Planning Commission Study Session

SUBJECT: DR20-47, BUSHTEX

DR20-47, Bushtex: site plan, landscape, grading and drainage, elevations, floor plans, lighting, colors and materials for approximately 3.15 acres, generally located east of the southeast corner of Cooper and Guadalupe Roads and zoned Light Industrial (LI).

PRELIMINARY
LANDSCAPE PLAN

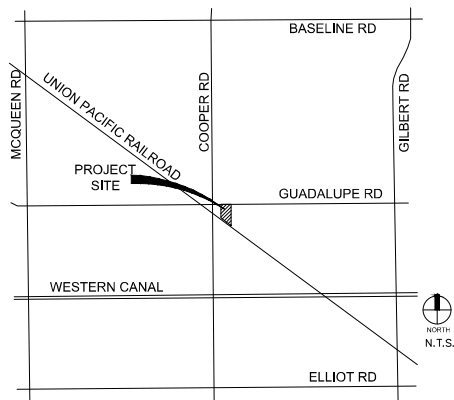
The site has some existing landscape to the north of the service yard wall. Additional landscape is proposed to meet landscape requirements including the addition of Mondel Pines, the street theme tree for the area. Landscape is not proposed behind the service yard wall as it is not required within fully enclosed industrial service yards. *1st review comments include modifying the landscape plan to reflect the existing right-of-way improvements.*

SHEET TITLE
EXTERIOR
ELEVATIONS

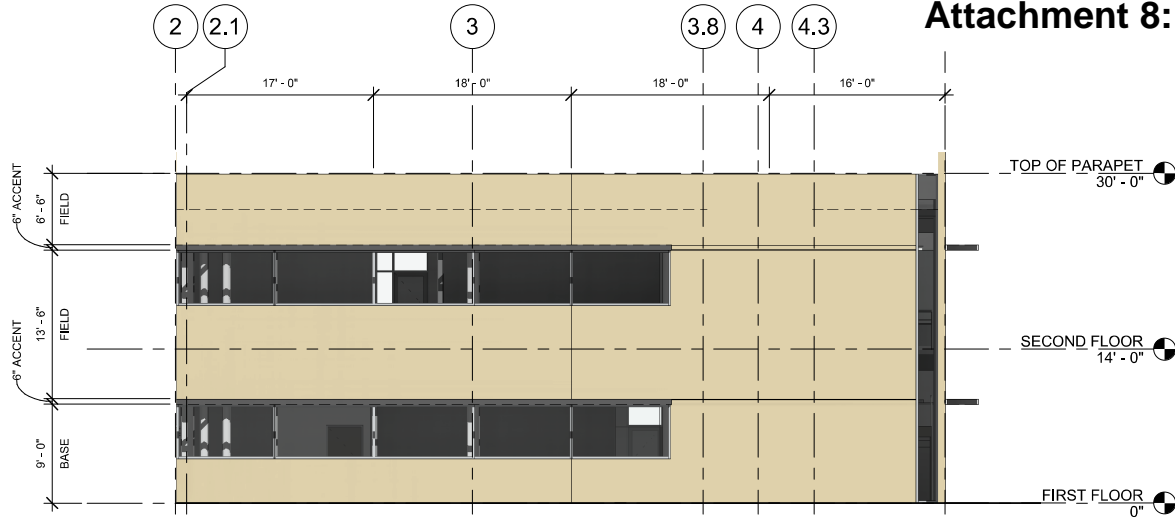
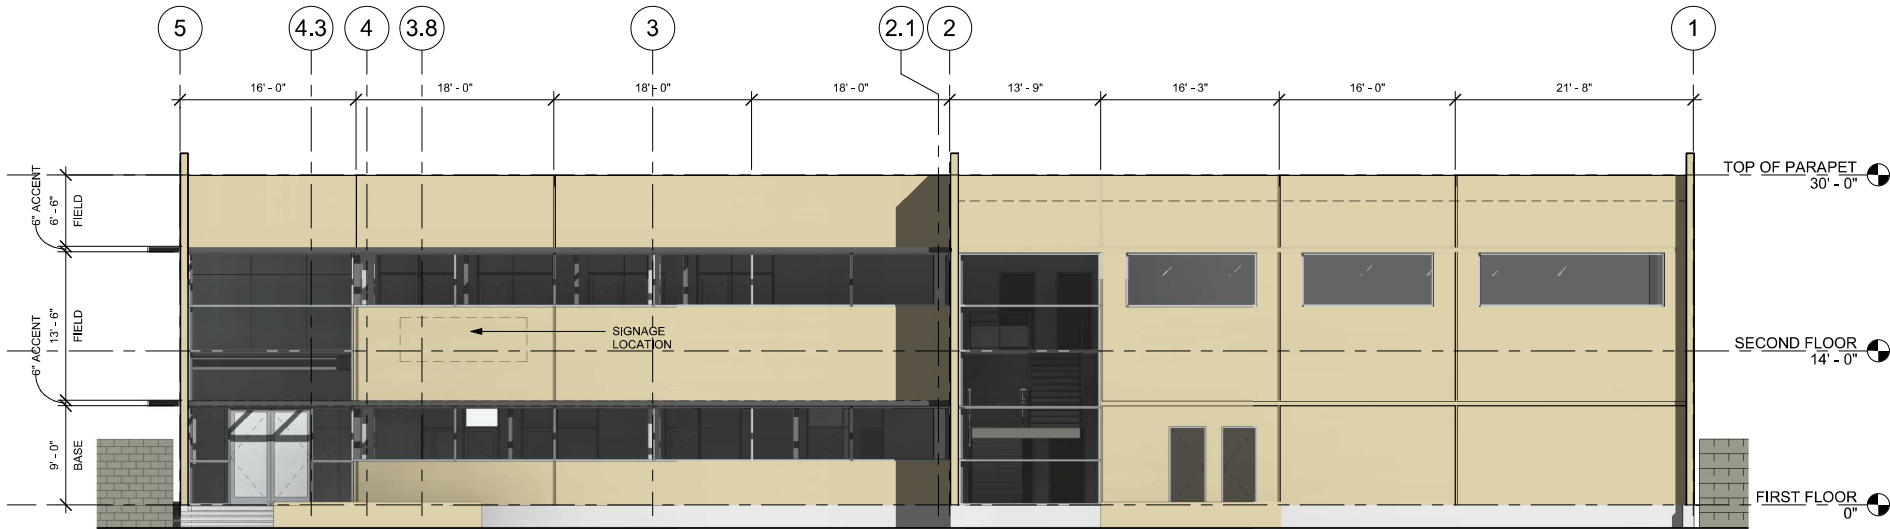
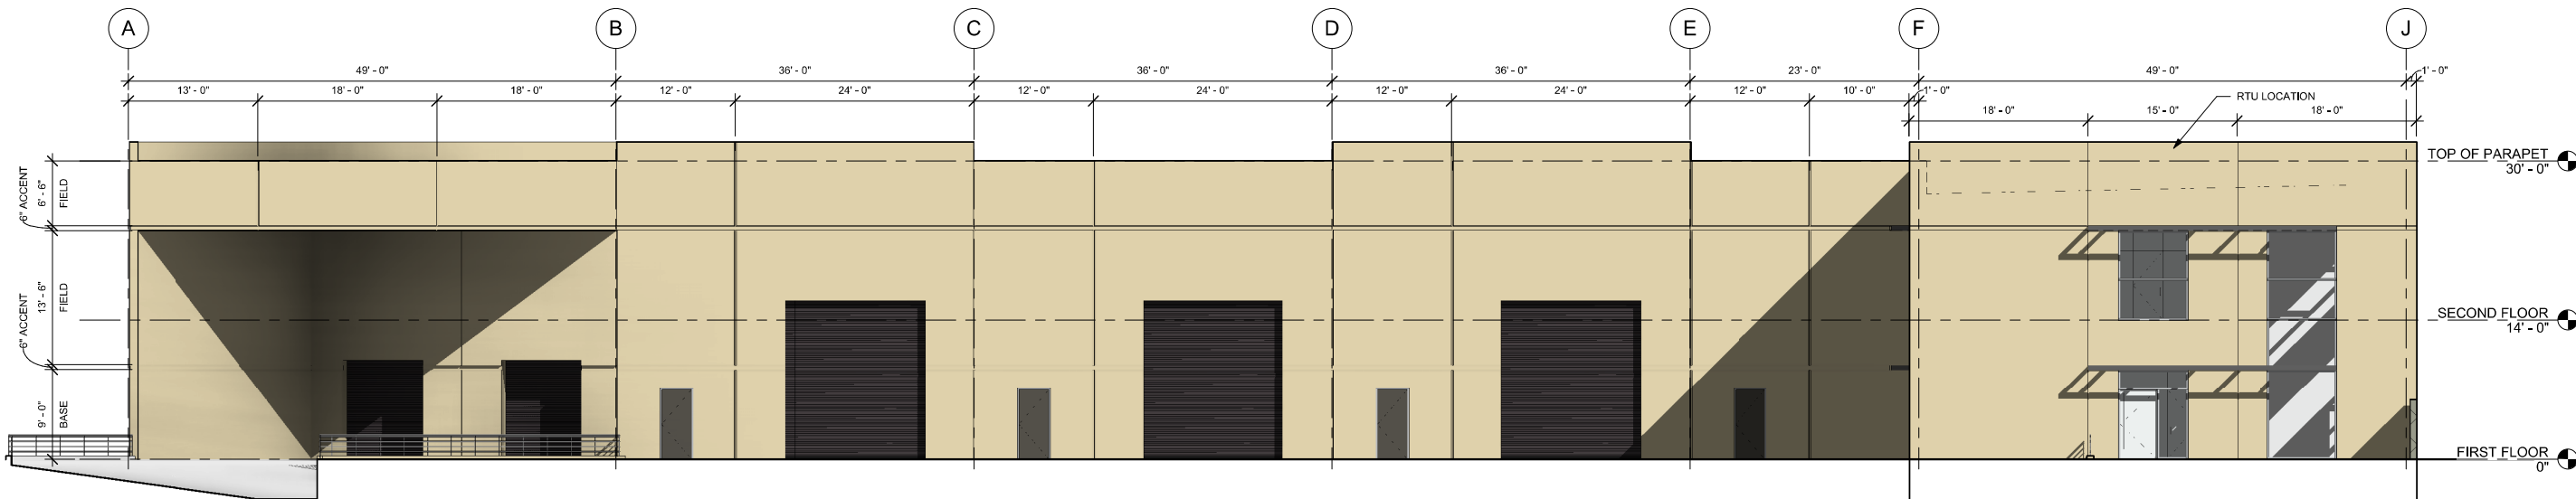
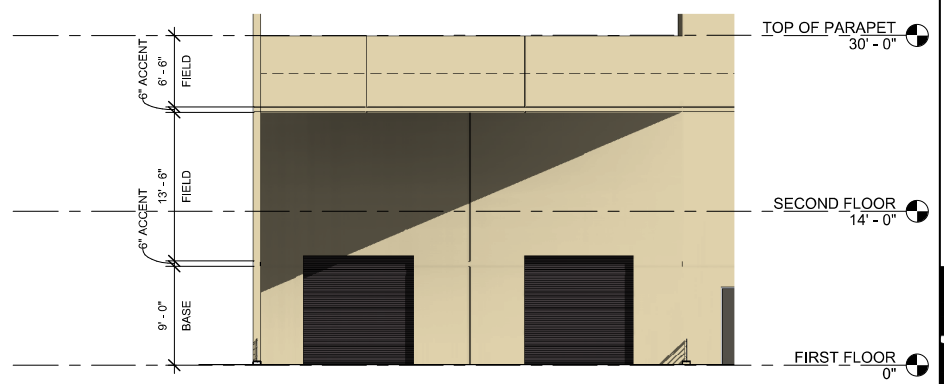
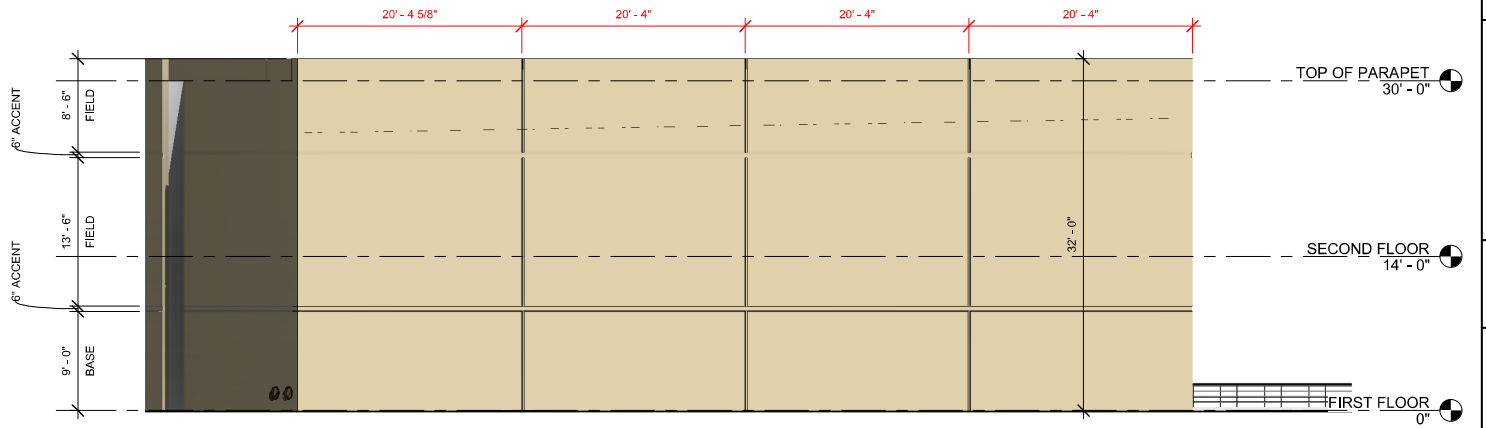
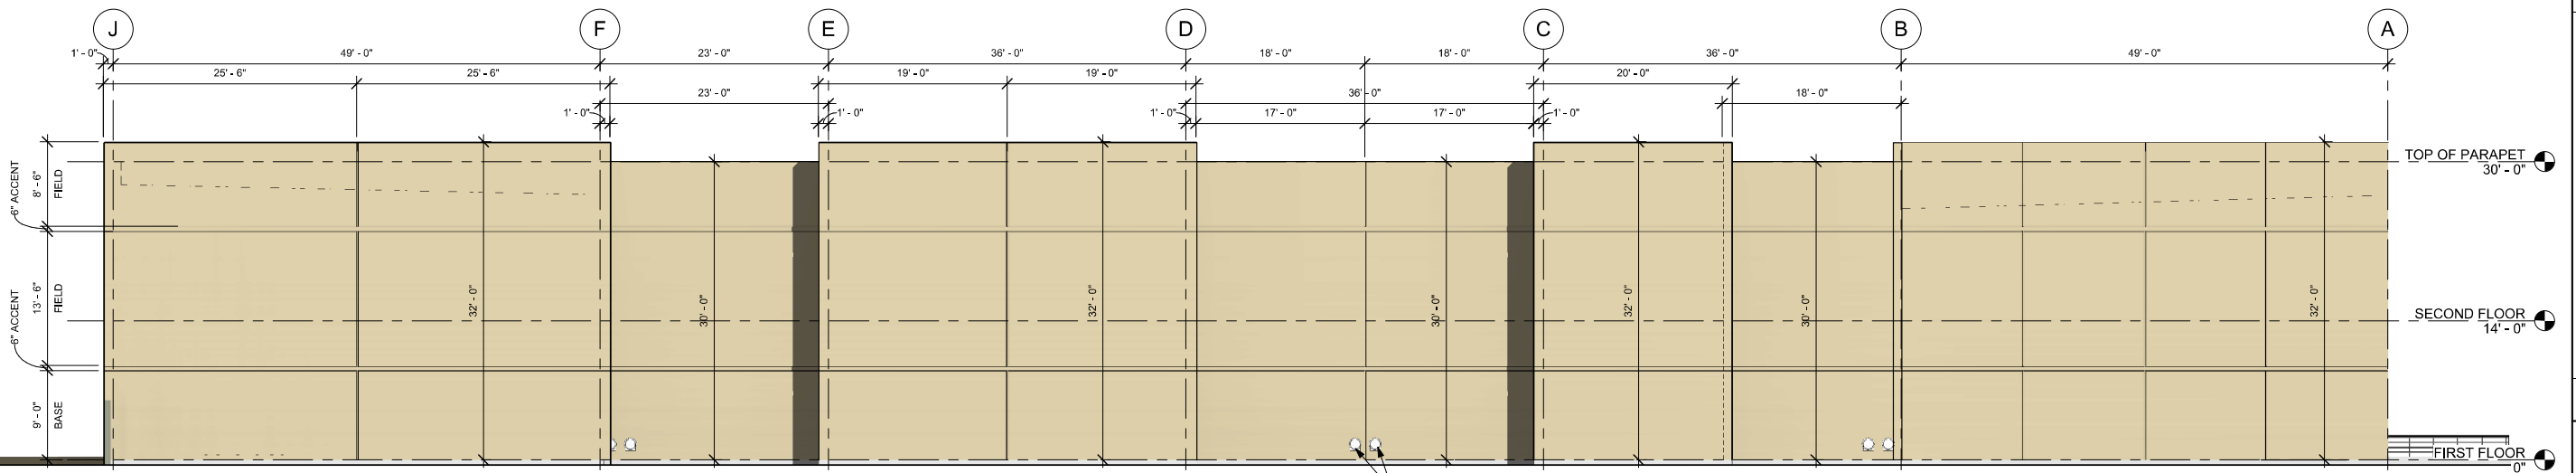
The height of the parapet is at 30’ with wing walls reaching 32’ in height. The floor plan shows a 2-story office along the north elevation with a warehouse at the rear. *1st review comments include revising the 2D elevations to better illustrate the color changes and exploring ways to add variety to the color of the building and providing metal canopies over windows that are proportionate in size to the mass of the building.*

SHEET TITLE
SITE LIGHTING
PHOTOMETRIC
PLAN

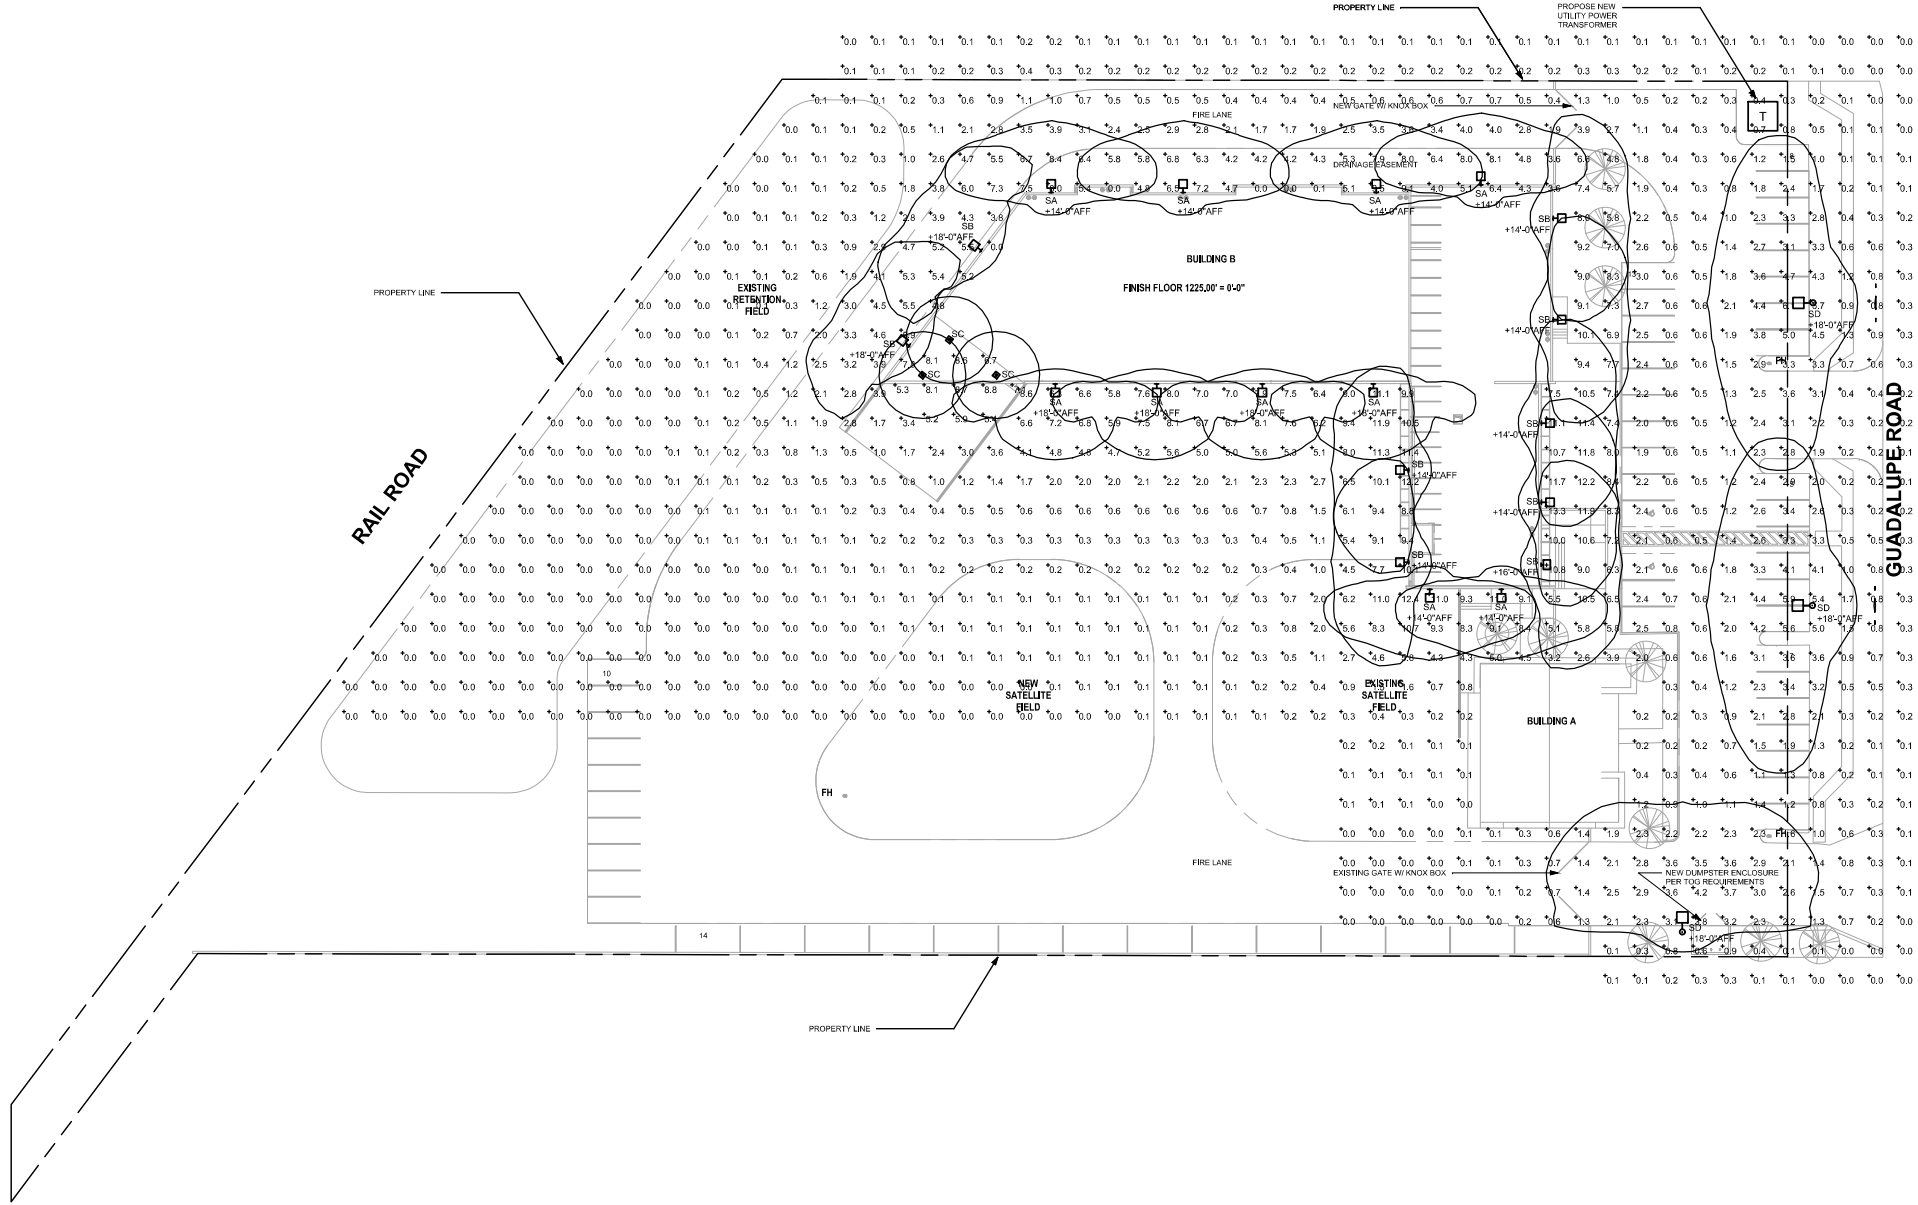
There are only three lighting types proposed: parking lot, building wall mounted, and recessed lighting at the loading dock. Building mounted lighting is proposed at 14’ height. *1st review comments include adjusting the parking lot lighting to meet town codes for location and level of illuminance.*
